Sundry Print Report

Well Name: EAGLE 34 E FEDERAL Well Location: T17S / R27E / SEC 34 / County or Parish/State: EDDY /

Type of Submission: Notice of Intent

Type of Action: Plug and Abandonment

EAGLE 34 E FEDERAL #70 Plugging Procedure

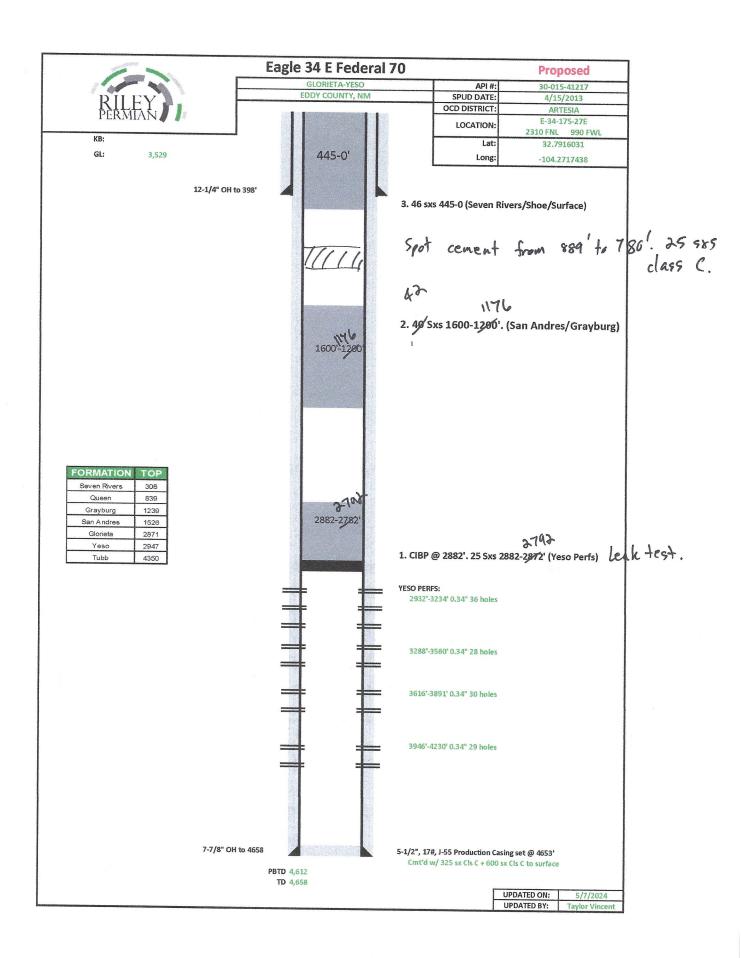
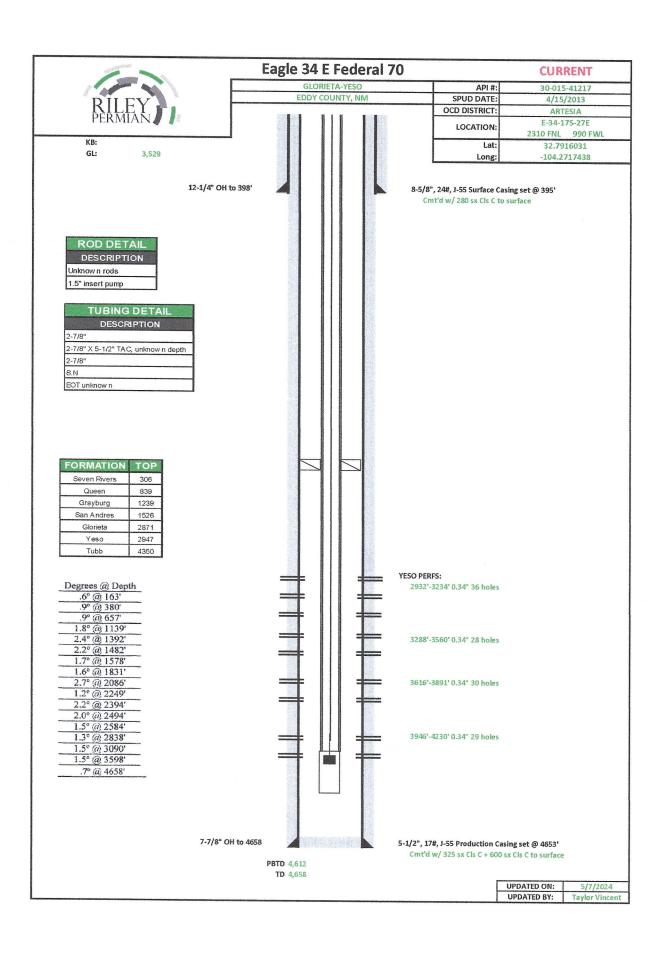
4. RIH w/HM Plug to 2882'. Load Hole w/9.5# MLF. Plug #1 25 SXS 2882-2872? Leak to the CLOP.

Spot cement from 889' to 780'. 25 8x5. Class C.
